Addendum Number Four

To The Drawings and Specifications for
Hadley Middle School – Wichita, Kansas
Wichita Unified School District # 259

Issued: April 28, 2010

HANNEY & ASSOCIATES ARCHITECTS

Tunnel Diagram – areas to be cleaned up are shown in yellow.

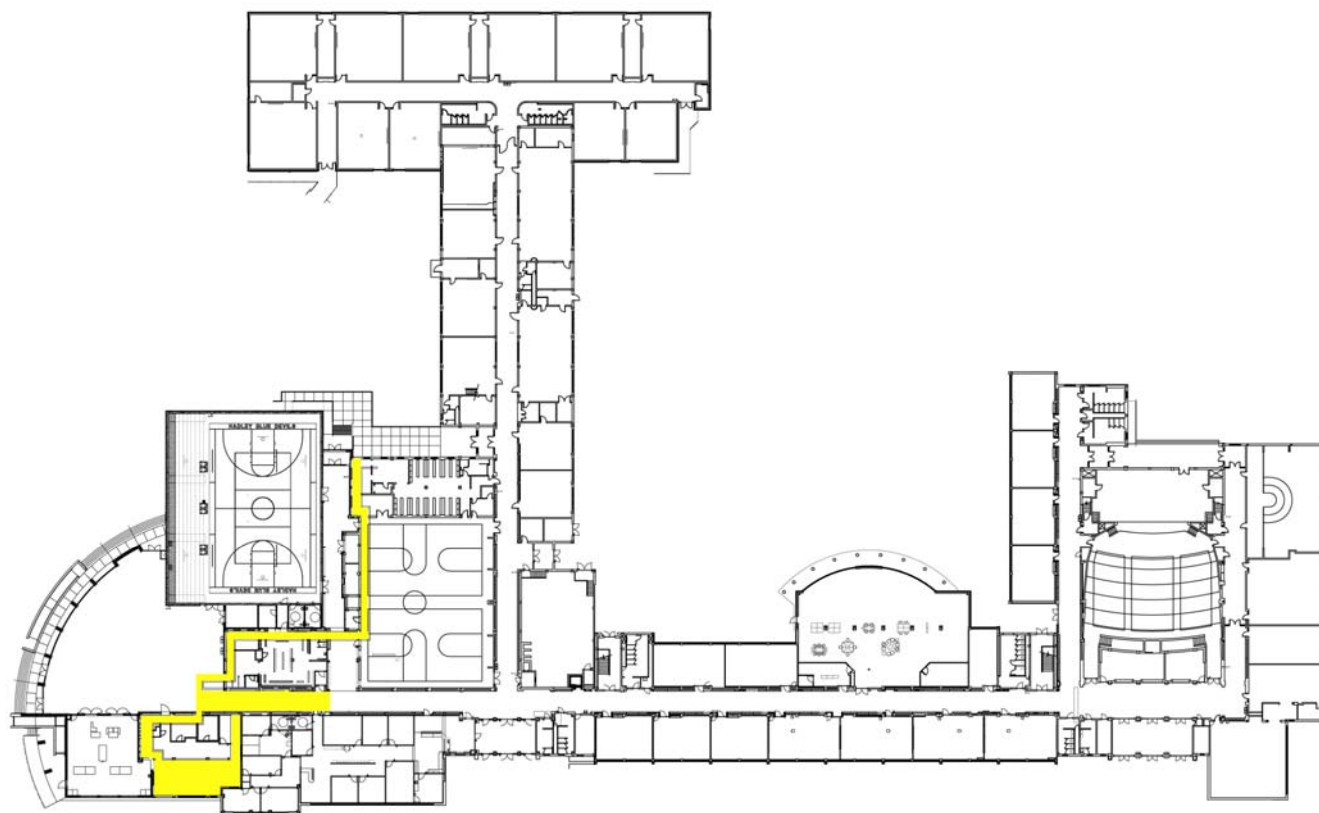
- 1.10 Tunnels:
- The tunnels were not cleaned up following the last bond issue. USD 259 instructions are to remove the debris from the portion of the tunnel system where this bond project will work. A diagram illustrating the portion of tunnel in this contract that shall be cleaned up is attached to this addendum. This shall be defined as the removal of all loose material and pipe, broom clean.
